Re: TCEQ Industrial Wastewater Discharge NORI for Permit Number  
WQ0005254000

The Texas Parks and Wildlife Department (TPWD) appreciates the opportunity to provide comment on the application for the proposed Texas Pollutant Discharge Elimination System (TPDES) industrial wastewater discharge permit for Port of Corpus Christi Authority of Nueces County. (Permit No. WQ0005254000). TPWD is the agency with primary responsibility for protecting the state's fish and wildlife resources (Texas Parks and Wildlife Code §12.0011(a)) in addition to encouraging outdoor recreation on Texas water resources. With respect to this role, we are concerned about water quality for fish and wildlife. Additionally, we are charged with providing information on fish and wildlife resources to any local, state, and federal agencies or private organizations that make decisions affecting those resources (Texas Parks and Wildlife Code §12.0011(b)(3)). Please be aware that a written response to a TPWD recommendation for informational comment received by a state government agency may be required by state law. For further guidance, please see Texas Parks & Wildlife Code Section 12.0011.

Figure 1. Location of Port of Corpus Christi Authority's desalination plant outfall per latitude/longitude in permit application and Technical Report 1.0.

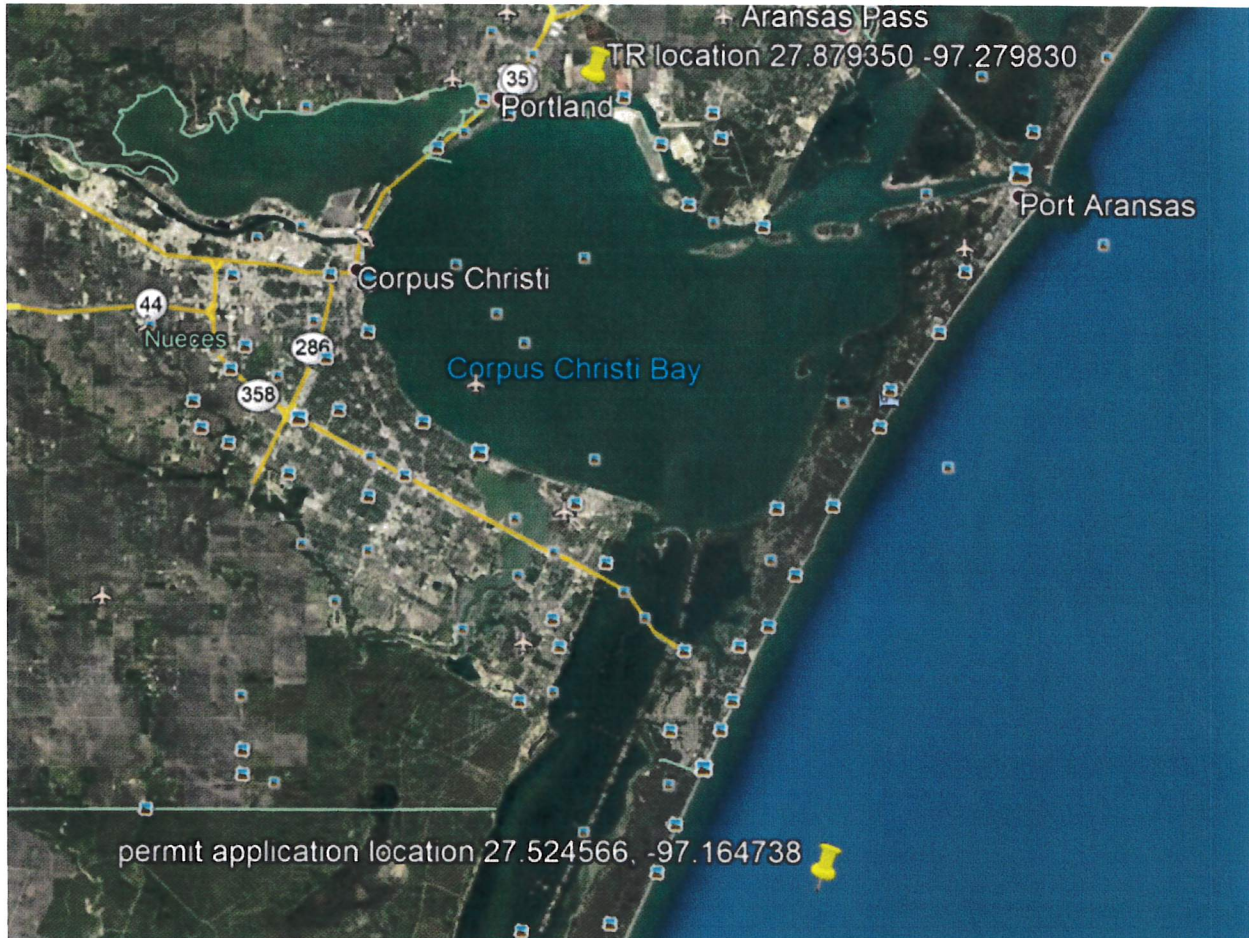
Based on the information provided in the permit application, there seems to be a discrepancy in the location of the outfall between the cited latitude/longitude in the first part of the application on page 9 (27.524566, -97.164738) and the one listed on page 6 of the Technical Report 1.0 found later in the application (27.87935, -97.27983). TPWD assume the location referenced in the Technical Report is the correct location. Attachment A to this letter contains a map (Figure 1) of the two locations listed in the permit application and Technical Report 1.0 and

TPWD would appreciate clarification from the applicant on this discrepancy.
